REM/Rate v15 Review

9/22/14

This document includes the results of limited testing and verification of the REM/Rate v15.0 software submitted as a simulation tool for demonstrating compliance with Section 405 of the 2010 FL Building Code, Energy Conservation. The testing was limited to some of the basic requirements due to time constraints and did not fully cover all aspects of the 2010 FL Building Code or the TAM.

Form 405 -10

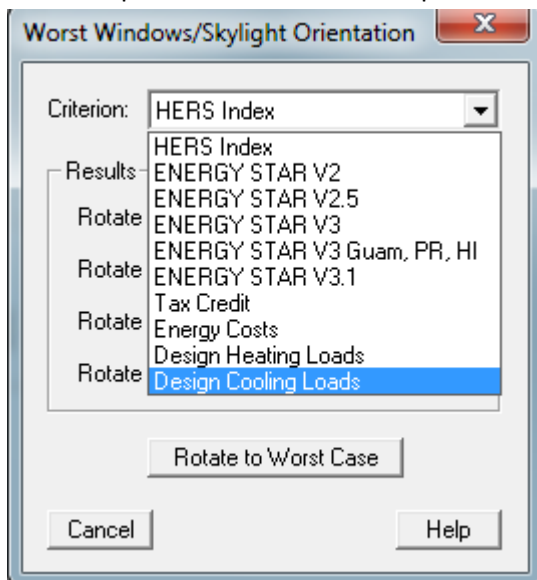
- Form 405-2010 does not include the Florida Seal.

Mandatory Requirements Screen

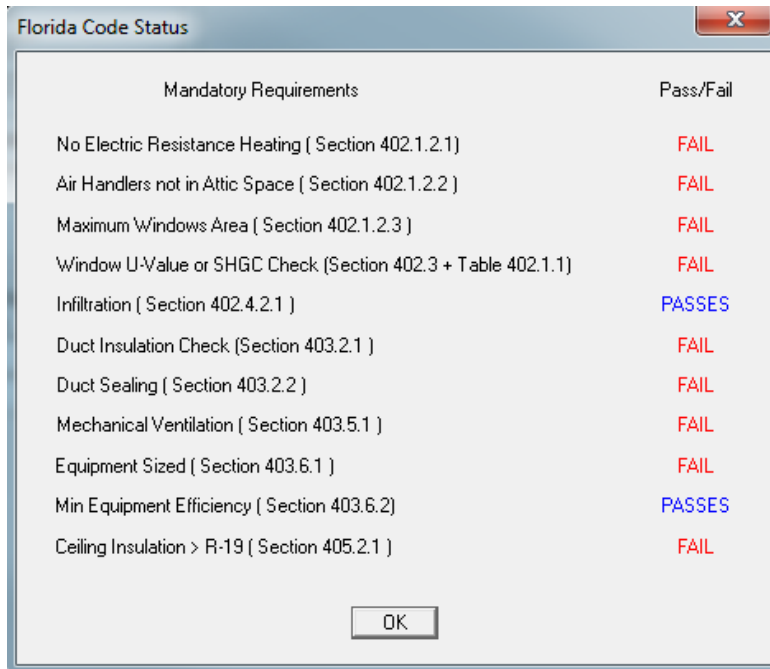
- REM/Rate provides a Mandatory Requirements screen when calculating Performance (Form 405) compliance; however, a number of the requirements it lists are prescriptive, not required for Performance compliance.
